BARRACUDA®, GOPHER, AND SL: NEW CARTRIDGE SWIVEL ASSEMBLY

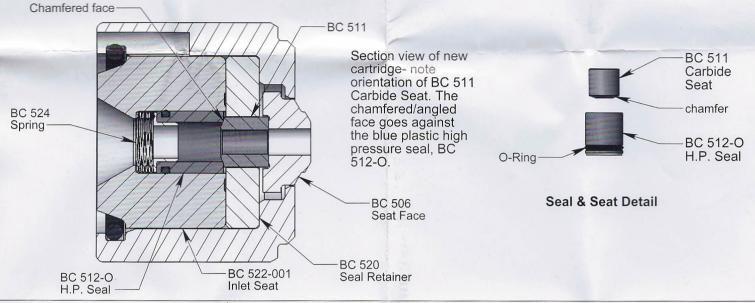
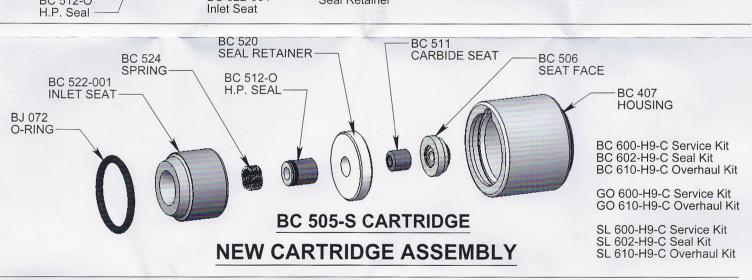
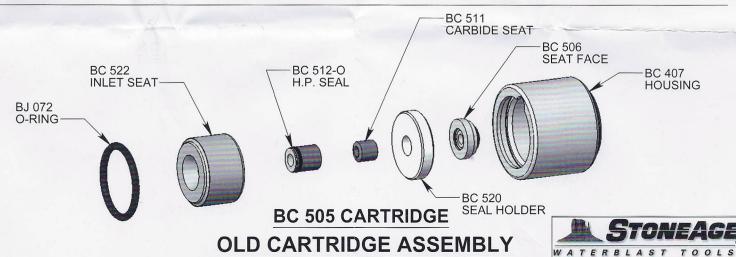
A design change has been made to the cartridge of the BC-H9-C Barracuda® to improve the seal life. The new cartridge part number is BC 505-S, which replaces the BC 505 cartridge. The cartridge assembly is interchangeable with all the existing Barracuda®, Gophers and SL swivels that use the cartridge, but some internal parts of the cartridge have changed. The Inlet Seat (BC 522-001) and the Spring (BC 524) are different. All of the other parts are interchangeable- refer to the exploded views below comparing the cartridges and be sure to use the correct part number for the new parts, assemblies and kits. Externally, the cartridge assemblies can be distinguished by pushing on the seat face; the new cartridge is spring loaded and the seat face will spring out, while the old one does not. When replacing the cartridge, inspect the end of the shaft in the swivel for damage such as galling or erosion- we recommend replacing damaged shafts. All kits include either the complete new cartridge or all the parts needed to rebuild the cartridge.
